DEVELOPMENT APPLICATION ASSESSMENT REPORT

Application Number:	DA2025/0344
----------------------------	-------------

Responsible Officer:	Kye Miles
Land to be developed (Address):	Lot 321 DP 848146, 16 Noorong Avenue FRENCHS FOREST NSW 2086
Proposed Development:	Alterations and additions to a dwelling house
Zoning:	Warringah LEP2011 - Land zoned R2 Low Density Residential
Development Permissible:	Yes
Existing Use Rights:	No
Consent Authority:	Northern Beaches Council
Land and Environment Court Action:	No
Applicant:	Jarra Hills (N.S.W) Pty Ltd

Figure 1. *Extent of north-western side boundary envelope non-compliance.*

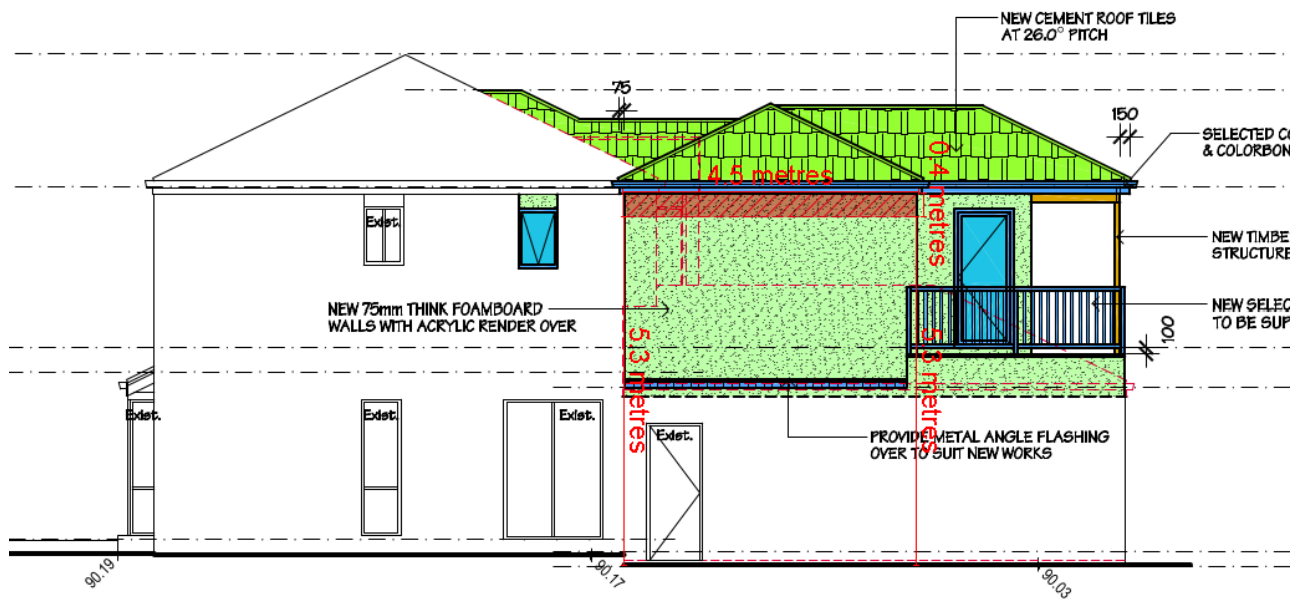
The proposal has one encroachment on the north-western elevation sized 0.4 metres for a length of 4.5 metres.

The proposal is appropriately articulated and incorporates materials that complement the existing built form and the surrounding environment. The proposal's height is proportionate to existing buildings, preventing any adverse visual impact. Additionally, the dwelling's size and massing are well-balanced, preserving the overall aesthetic and character of the area. Overall, the building, by virtue of its height and scale, remains consistent with the desired character of the locality.

The spatial separation proposed between buildings is considered appropriate within the low density setting. In addition, the variations sought to the side boundary envelope do not contain any intrusive windows. Furthermore, the submitted shadow diagrams demonstrates compliance with WDCP's access to sunlight control. Overall, it is considered that the proposal ensures adequate light, solar access and privacy by providing reasonable spatial separation between buildings.

The first floor extension is located above the existing building footprint and does not require any excavation.

Having regard to the above assessment, it is concluded that the proposed development is consistent with the relevant objectives of WLEP 2011 / WDCP and the objectives specified in s1.3 of the Environmental Planning and Assessment Act, 1979. Accordingly, this assessment finds that the proposal is supported, in this particular circumstance.

Figure 2. Front setback non-compliances.

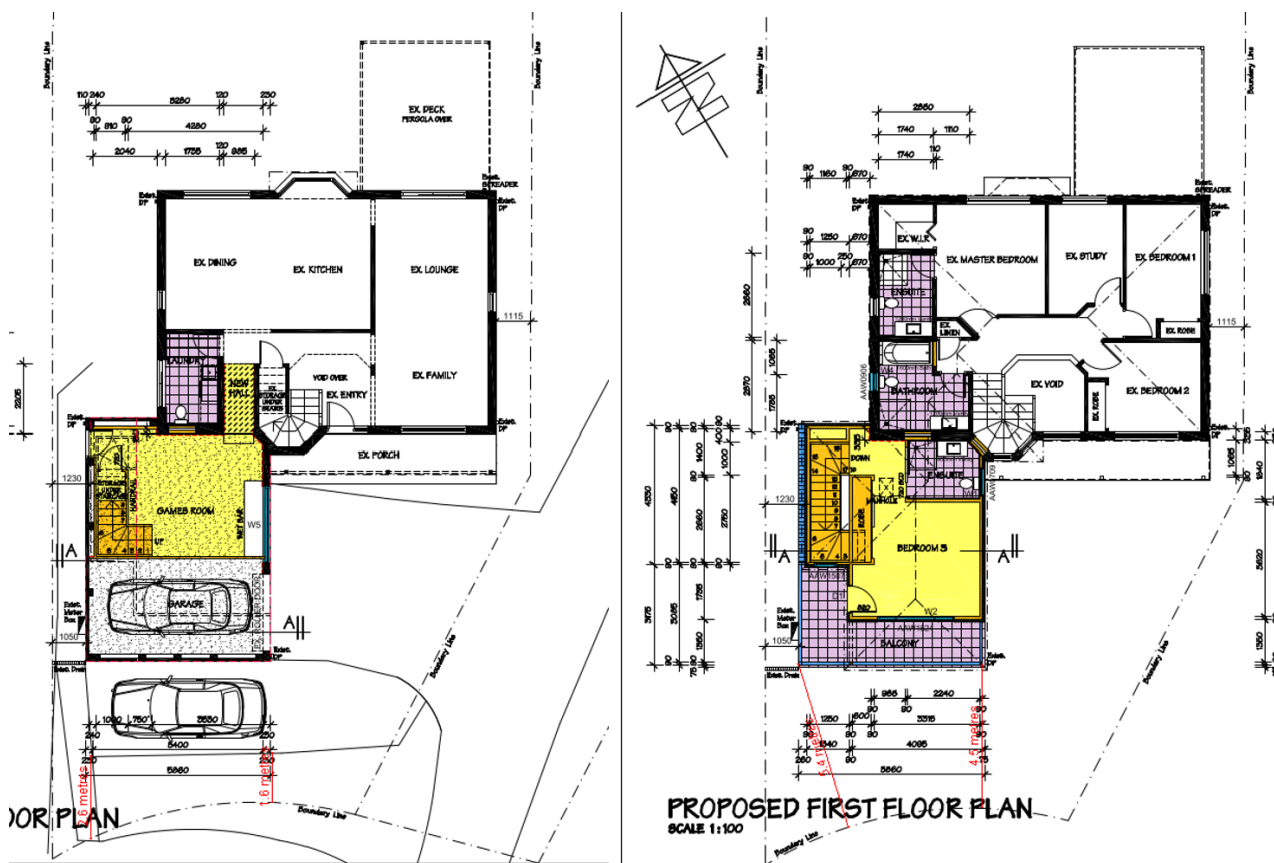
The proposed southwest corner of the upper floor study is set back at a minimum of 4.5 metres from the front boundary. In addition, the proposal seeks allocate an off-street parking space within an existing hardstand that is set back at a minimum of 1.6 metres from the front boundary. This control requires development to be setback at least 6.5 metres from the front boundary.

The front setback area will retain a consistent level of openness within the streetscape. It is noted that the extent of variation is associated with the existing positioning of the built form on site and the curved frontage.

The proposal will be integrated within the existing roof form to maintain continuity between buildings. In addition, the proposal will not require the removal of any landscape elements in the frontage, maintaining the streetscape character. It acknowledged, the proposed hardstand parking area within the frontage may be unique in nature, as surrounding sites do not contain formalised hardstand parking structures. However, surrounding sites are seen to contain wide driveways and carports within the front setback that are primarily occupied by two cars. In addition, the subject site benefits from a wide section of the road reserve, which minimises any unreasonable visual impact upon the streetscape. Therefore, the proposal will not unreasonably impact the visual continuity between buildings as it is reasonably compatible with the surrounding built environment.

The design of the proposal will modernise the appearance of the dwelling, which will contribute to the already diverse streetscape (by virtue of architecture and construction). The proposed encroachment within the front setback largely relates to the open balcony, which is an ancillary, subservient structure within the established front building line. The development is considered to be complementary and enhancing to the visual quality of the streetscape.

The proposal will not result in the loss of views.

Having regard to the above assessment, it is concluded that the proposed development is consistent with the relevant objectives of WLEP 2011 / WDCP and the objectives specified in s1.3 of the Environmental Planning and Assessment Act, 1979. Accordingly, this assessment finds that the proposal is supported, in this particular circumstance.
